Re: Observation on the Lemanaghan Wind Farm. Case Reference: 324161

Please find below my observation relating to the proposed Lemanaghan Wind Farm. I am a professional historian with expertise in Irish history, and I also have extensive first-hand experience of the landscape of the Irish midlands. I have already written several more detailed observations in relation to the Hill of Uisneach and the proposed Umma More Wind Farm (Case No. 321595). In the context of the planned UNESCO nomination for the Royal Sites of Ireland, some of the significant issues that arise in relation to the Umma More are also of relevance to the Lemanaghan project.

Figure 14-10 WCDP Figure 13.2 'Hill of Uisneach Panoramic View and Buffer Zone' overlain with a ZTV

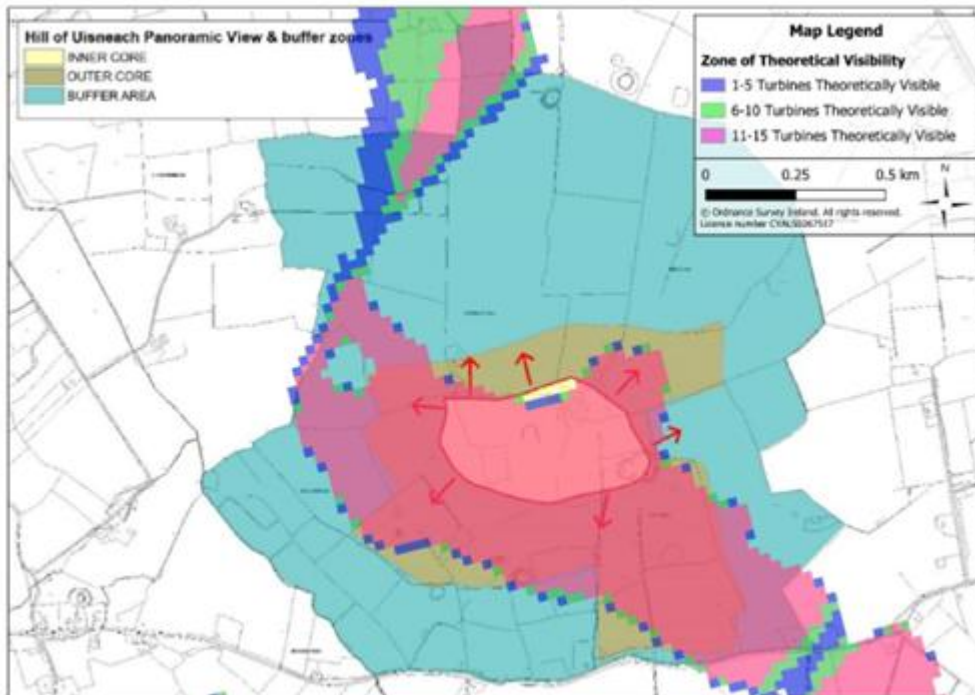
Again, these ‘mitigating factors’ are also copied directly from the Umma More EIAR. These claims are contradicted by the ZTV mapping in the Lemanaghan EIAR, Chapter 14 at p. 38, which in fact shows theoretical visibility of 11-15 turbines from substantial areas of the Uisneach hilltop, and its south and west sides, and most certainly not just the ‘south-western aspect’.

Map from Lemanaghan EIAR, Chapter 14, p. 38, showing visibility from most of the Hill of Uisneach.

This Lemanaghan ZTV indicates visibility from the key hilltop area where most of the culturally significant monuments are located. The assertion that there are 'large areas' containing 'culturally significant monuments' from where the Lemanaghan wind farm would not be visible is therefore not credible. It is clear that the Viewpoint Assessment presented for Uisneach and Lemanaghan has involved taking some shortcuts. It is simply not good enough to borrow inaccurate 'mitigating factors' from another project. This practice reinforces the need for an appropriate expert to be employed.

Moreover, for a tentative UNESCO site, it would be more appropriate to use a blade-tip ZTV, rather than a half-blade ZTV. This has been done, for example, for the current live application relating to Rathcroghan Royal Site and the proposed Carrigeen Wind Farm (Case No. 32417). While the 2006 Wind Energy Guidelines recommend half-blade ZTV, it is important to note that turbine blades have more than doubled length since 2006. This ought to render the half-blade approach altogether obsolete.
